RIVERPLACE PARCEL 3
DESIGN ADVICE REQUEST II PACKAGE

03.28.2016

DAR | FEBRUARY 18, 2016

SITE CIRCULATION & ACCESS

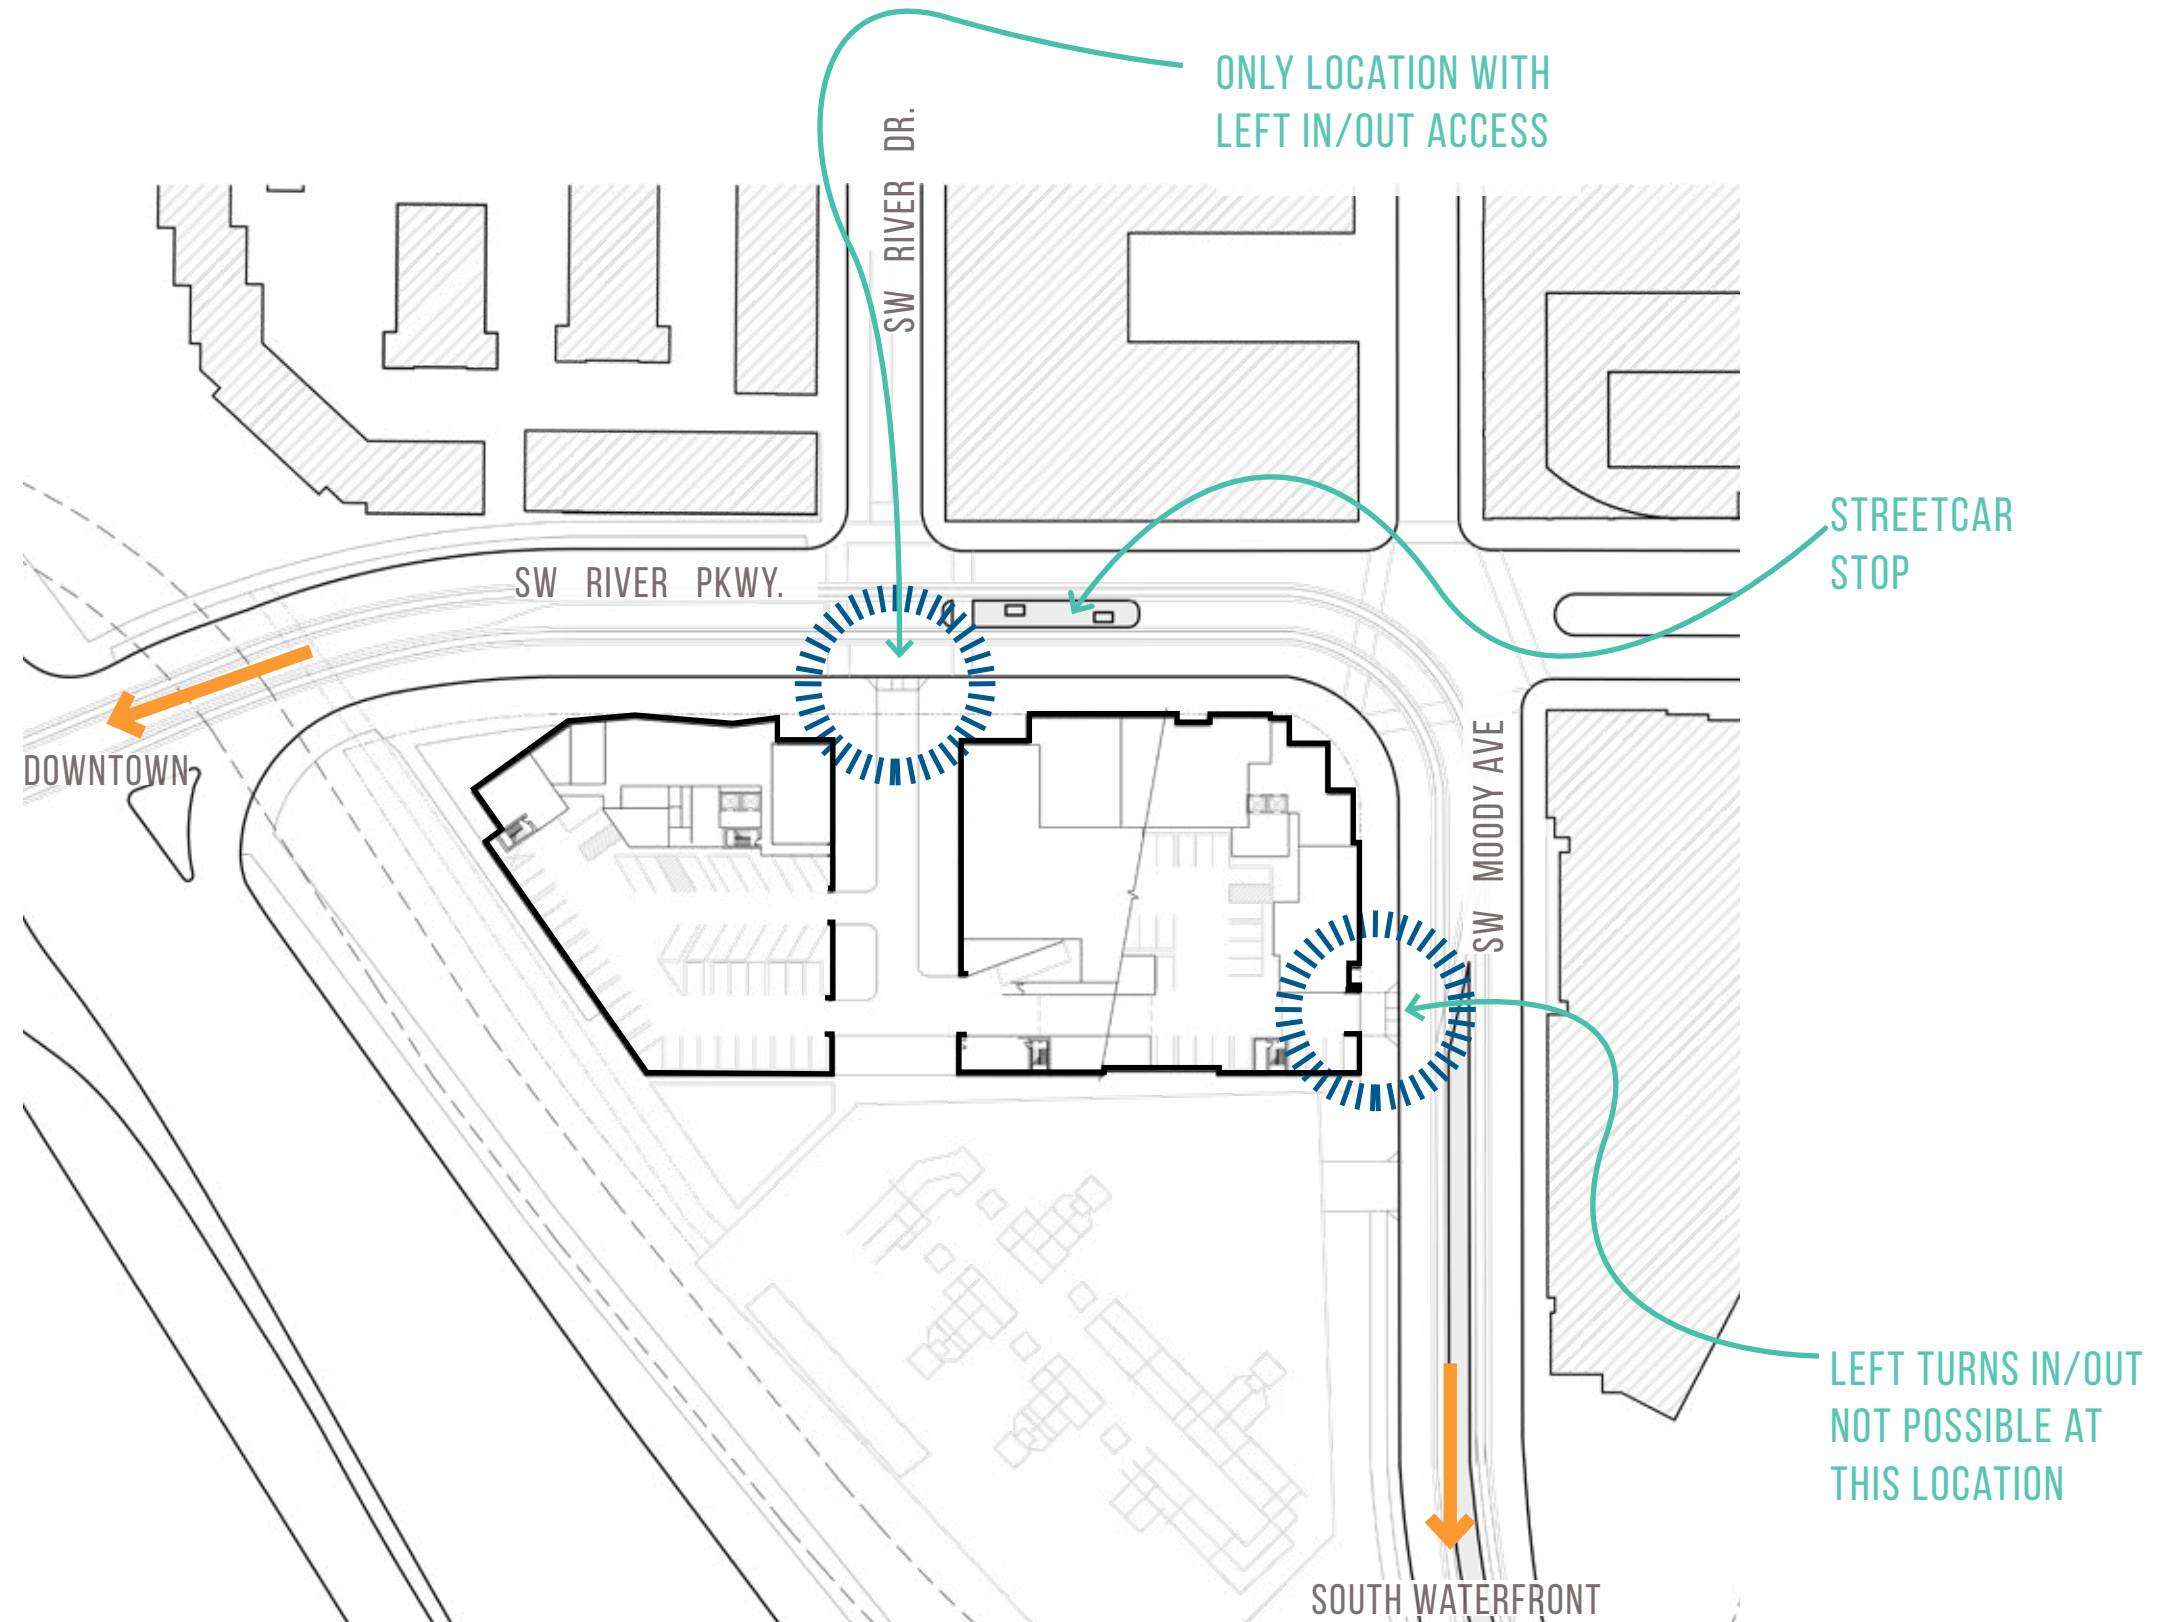
- Provide majority and preferably all parking access from southwest access from southwest Moody Ave.

- Because of the complication of the streetcar lines/ stop and vehicle traffic access to the site from along SW River Drive is required.
- A left turn in and out is not possible because of the streetcar line along Moody.
- With some signal adjustments a left turn into the site can be created at the River Drive / River Parkway intersection.
- With limited on-street parking near the site there is a necessity for easy automobile access from all directions to create viable retail space.
- Residential parking load requires two access points and left in and out.

PRIVATE STREET PLAN

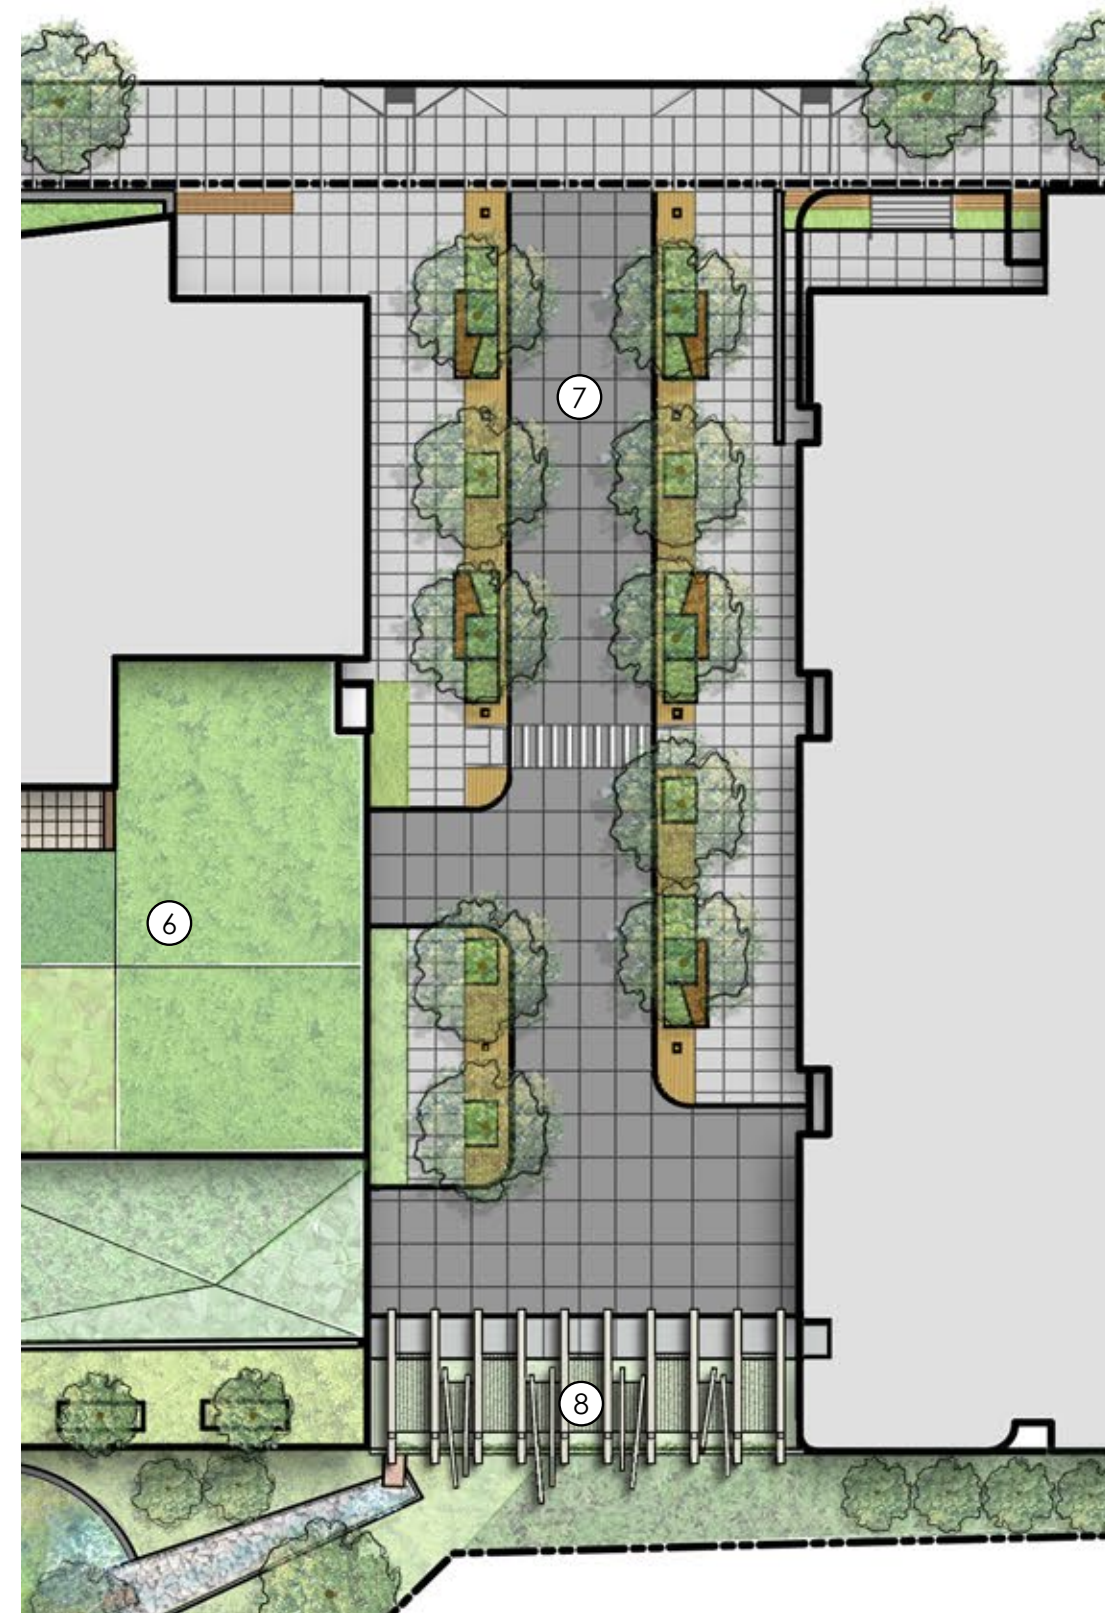
- Clearly define the character and the nature of this new street.
- Outdoor space is too undefined.
- Needs to be something engaging that contributes to the success and vitality of your project and the neighborhood.
- Serve to help the two buildings relate to each other.

- The space is required to be a private access-way into the site.
- The space serves as an extension of River Drive and feels like a street.
- The buildings are different in program, massing, architecture, and the people they serve.
- The private street creates a functional dialogue that allows shared circulation, parking access, and fire truck access.
- The private street creates an architectural dialogue where architecture meets to create a street.
- A 'Trellis Screen' completes the street, ties the buildings together and creates a repeatable pattern that begins to tie the buildings together along the south elevation and introduces a dialogue with the substation and infrastructure to the south.

PRIVATE STREET - EAST ELEVATION OF THE WEST BUILDING

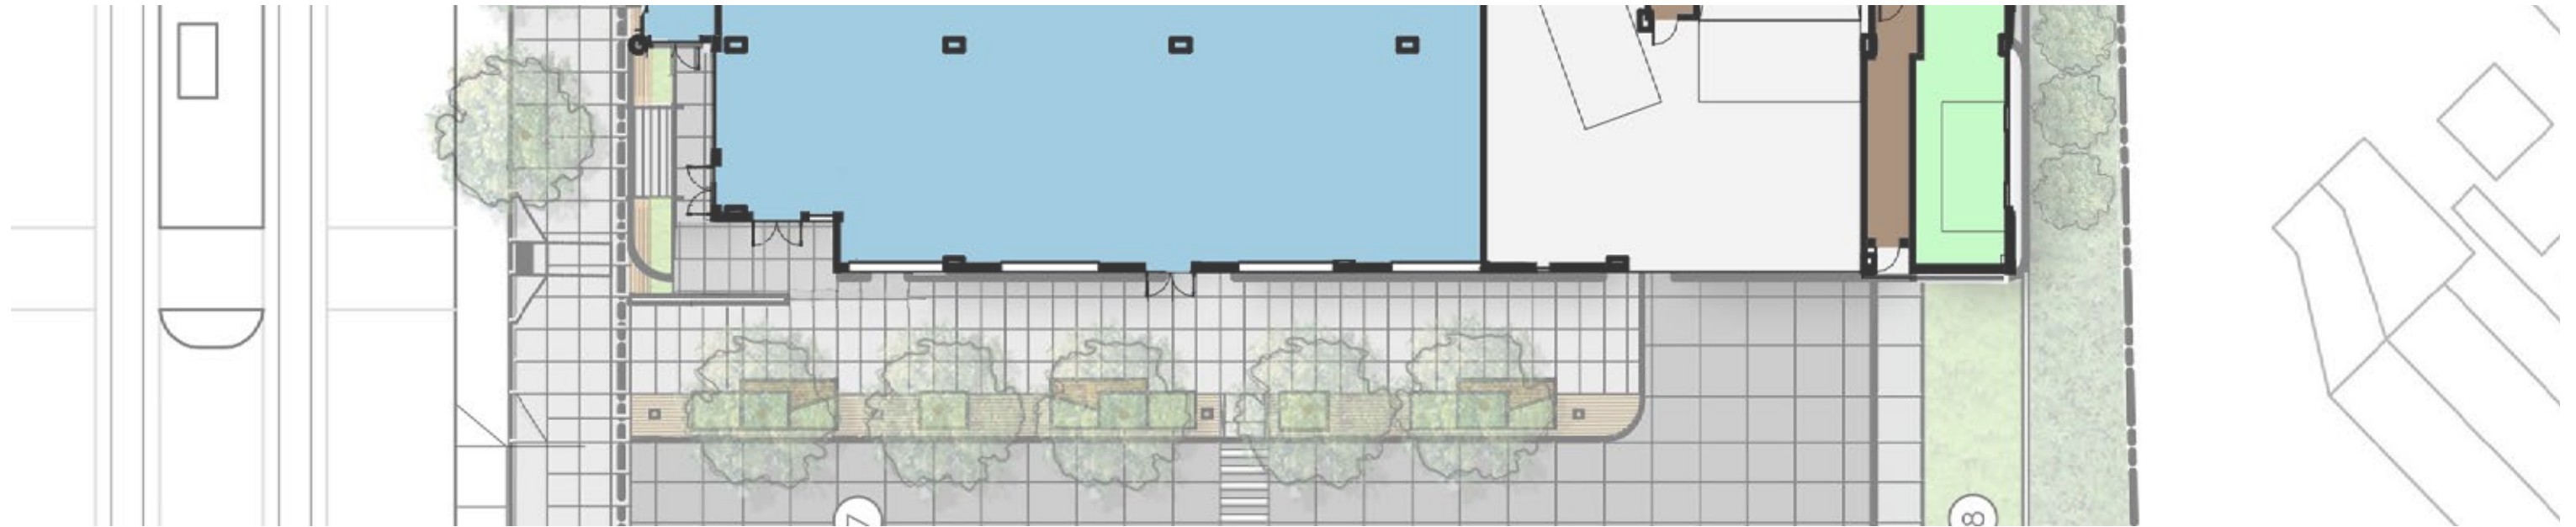
- Clearly define the character and the nature of this new street.
- Outdoor space is too undefined.
- Needs to be something engaging that contributes to the success and vitality of your project and the neighborhood.
- Serve to help the two buildings relate to each other.

- The private street is designed to function as a street with sidewalks on either side.
- Similar to most urban conditions in Portland and Riverplace neighborhood the distinct architectures of the buildings meet at this private street.

PRIVATE STREET

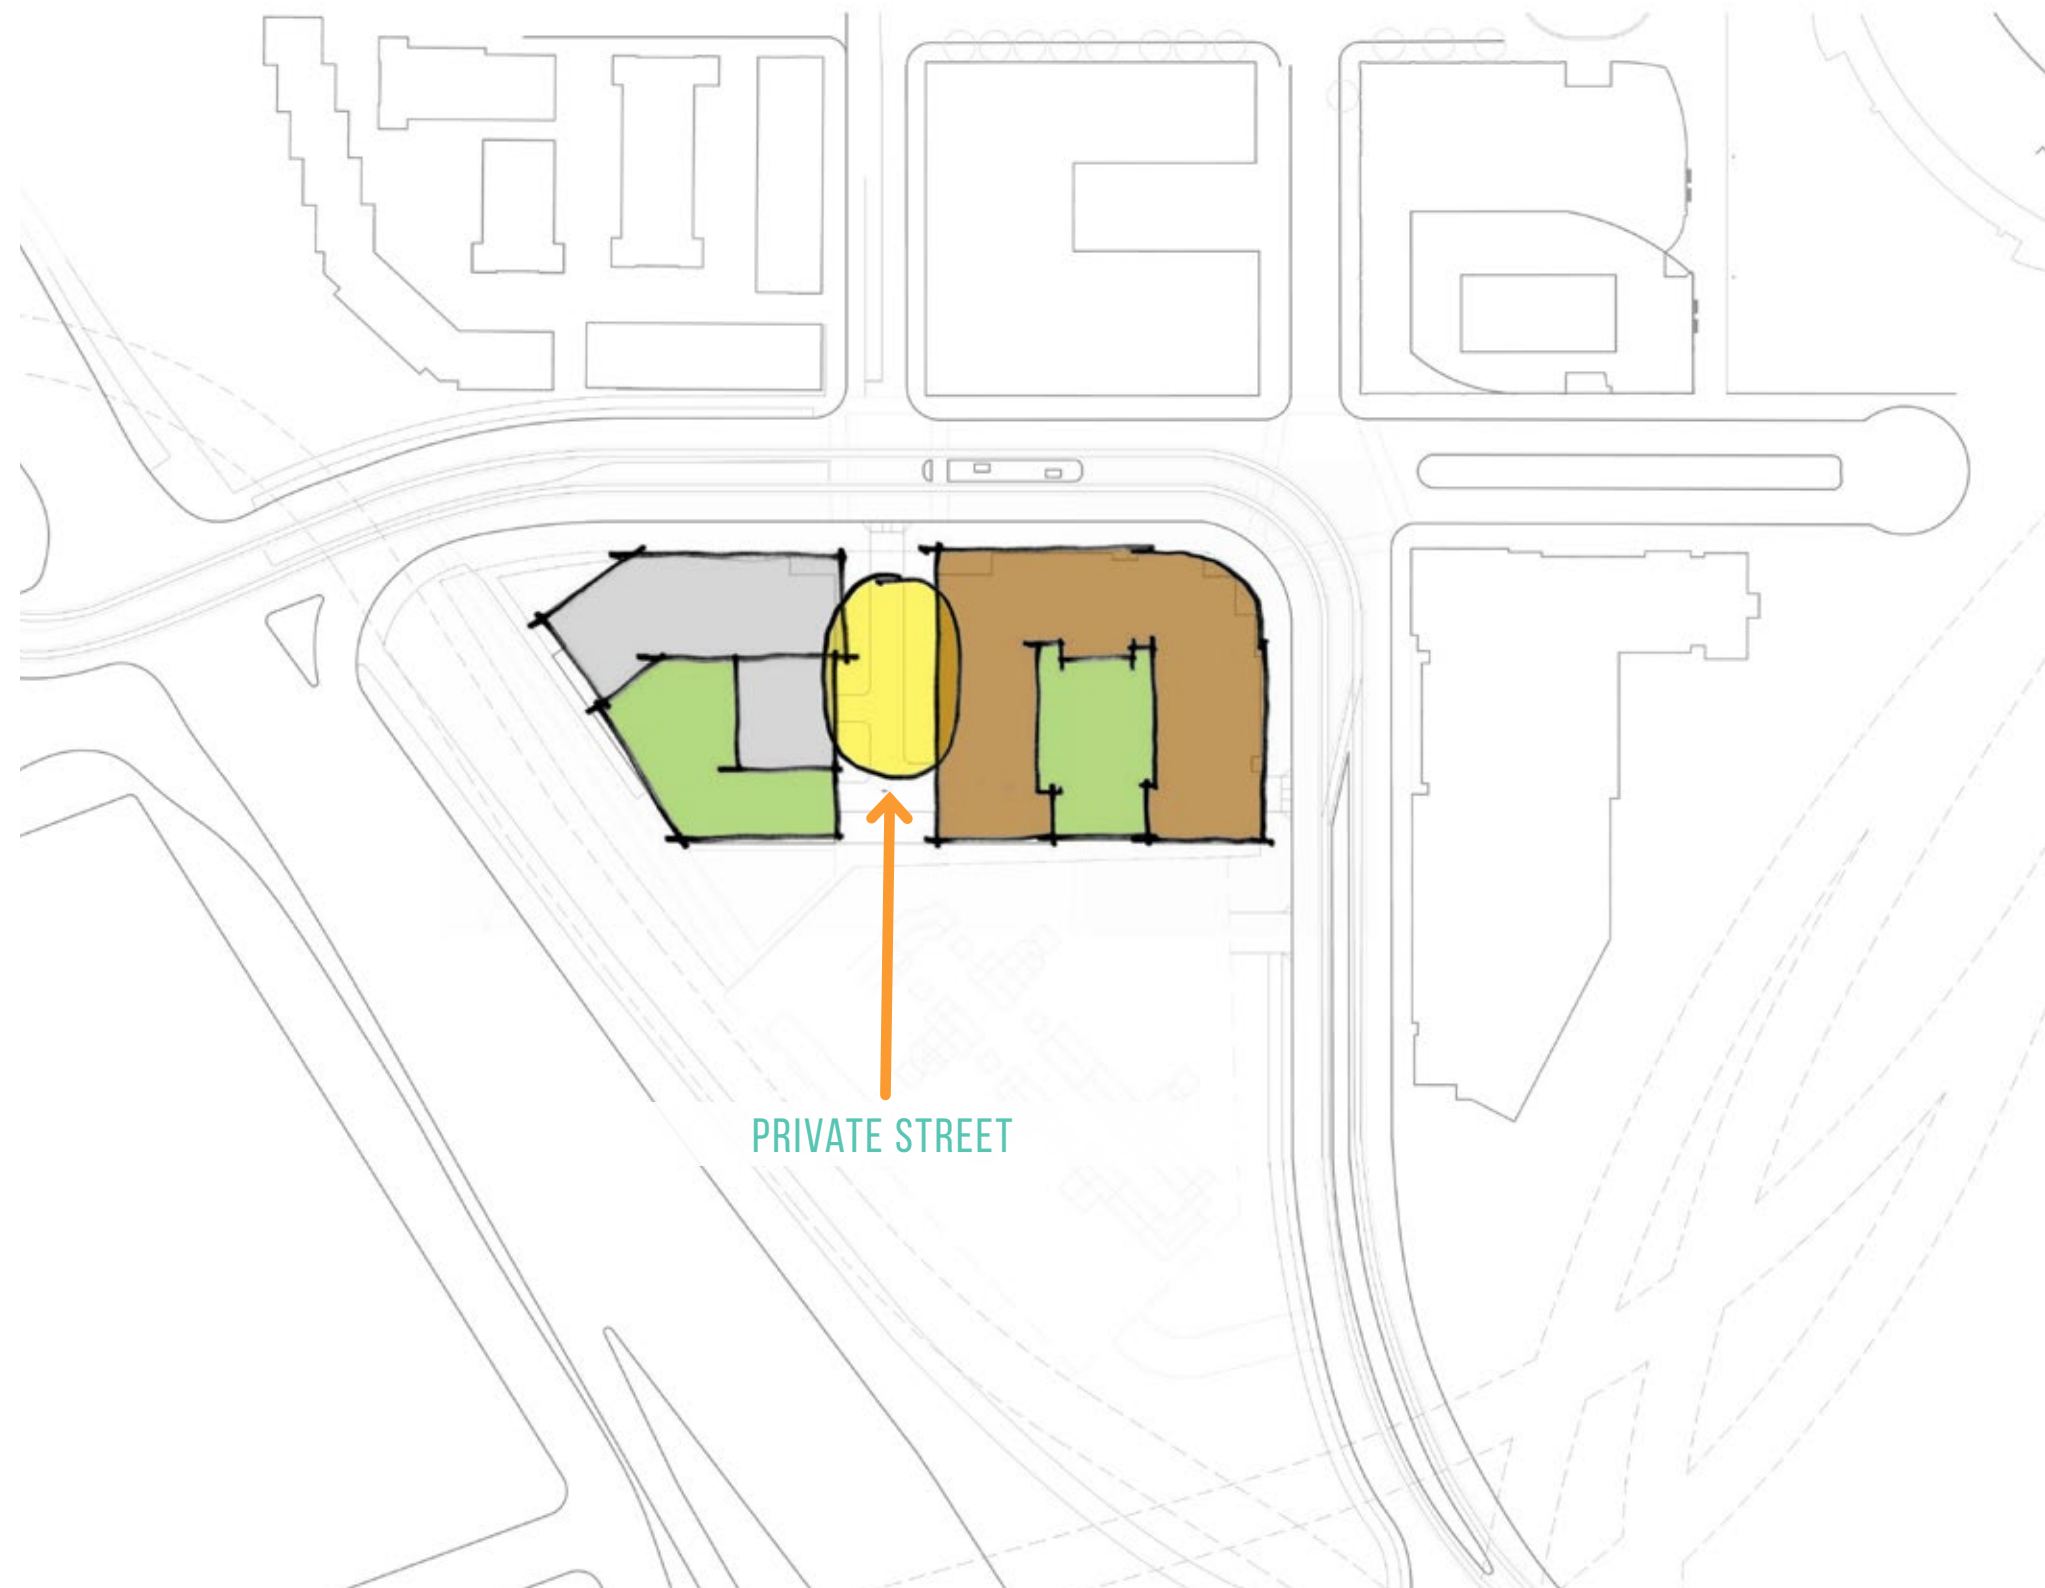
- Clearly define the character and the nature of this new street.
- Outdoor space is too undefined.
- Needs to be something engaging that contributes to the success and vitality of your project and the neighborhood.
- Serve to help the two buildings relate to each other.

- The buildings are different in program, massing, architecture and the people they serve. This street allows for a dialogue between buildings.
- An architectural dialogue where architecture meets to create a street.
